AM62Q x8NAND CARD - REVA

ECR/ECN DOCUMENT

BRIEF DESCRIPTION OF THE CHANGE TO BE IMPLEMENTED

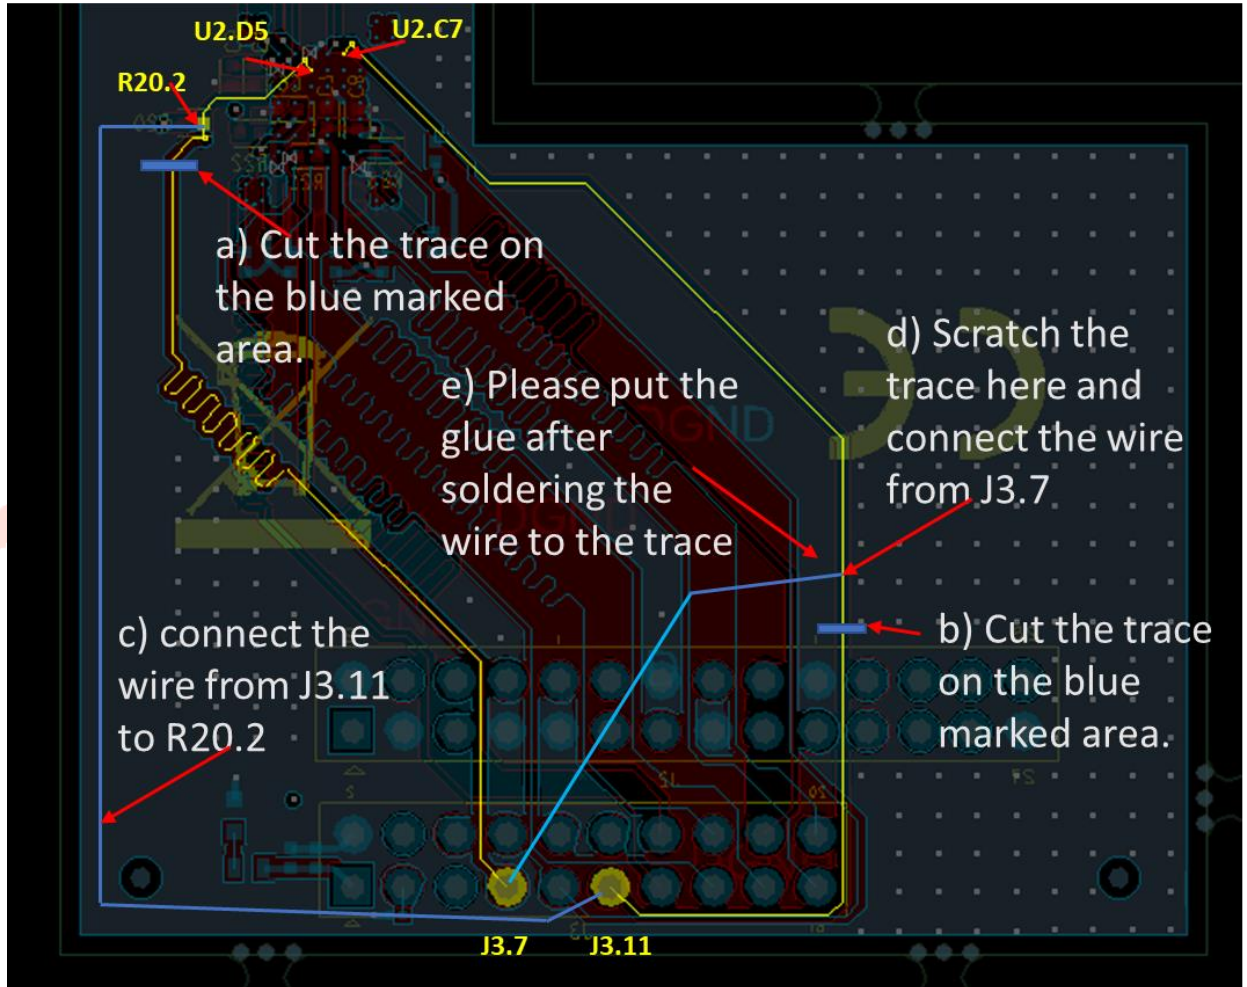
ECR#	ECR Description	ECN	Remarks
1	CLE and WE signals are swapped.	a) Cut the trace between J3.7 to R20.2. b) Cut the trace between J3.11 to U2.C7

- c) Connect R20.2 to J3.11 with copper wire to route CLE to GPMC0_BE0N_CLE on PRU HEADER pin 11.
- d) Connect U2.C7 trace to J3.7 with copper wire to route WE# to GPMC0_WEN on PRU HEADER pin 7.
- e) Put the glue after soldering the wire to the trace.

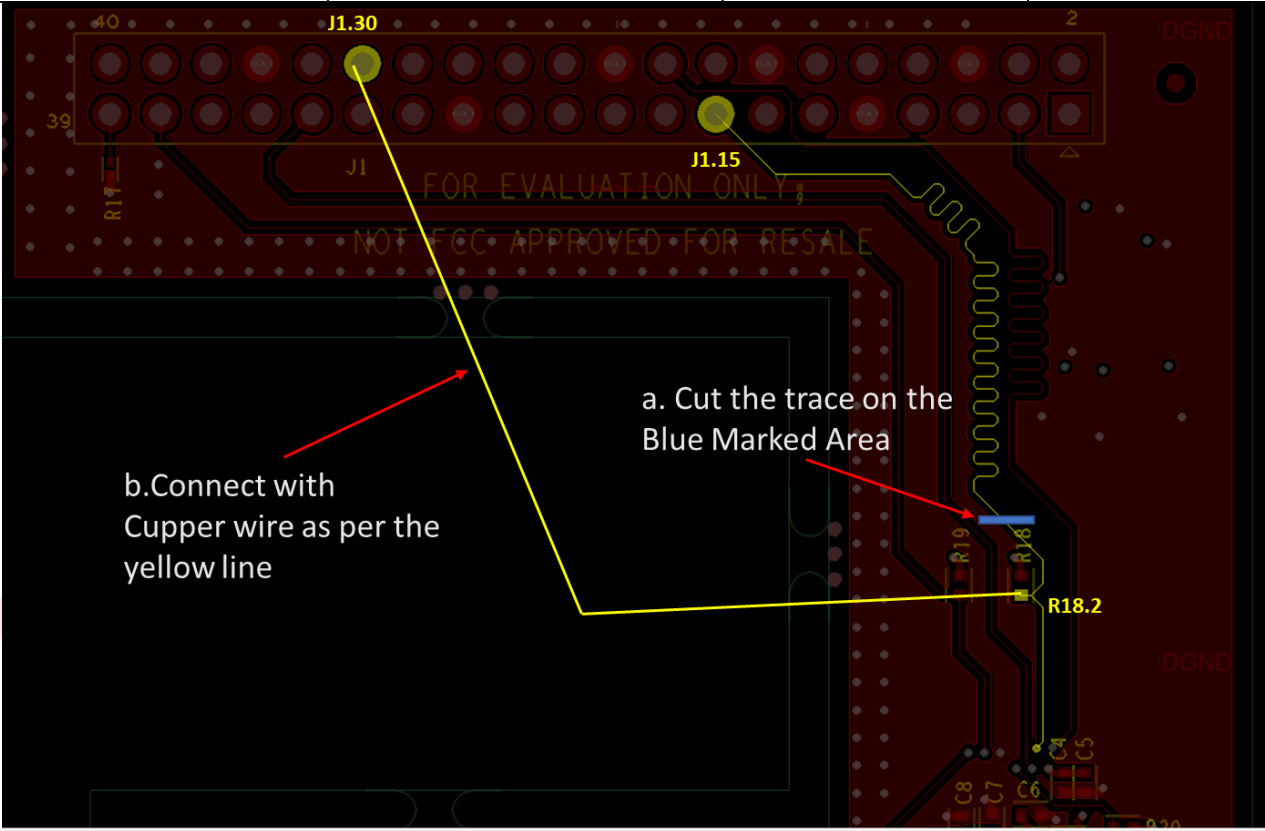
2	ALE is routed to the wrong pin	a) Cut the trace between R18.2 to J1.15. b) Connect R18.2 to J1.30 with copper wire to route ALE to GPMC0_ADVn_ALE on USER EXPANSION HEADER pin 30
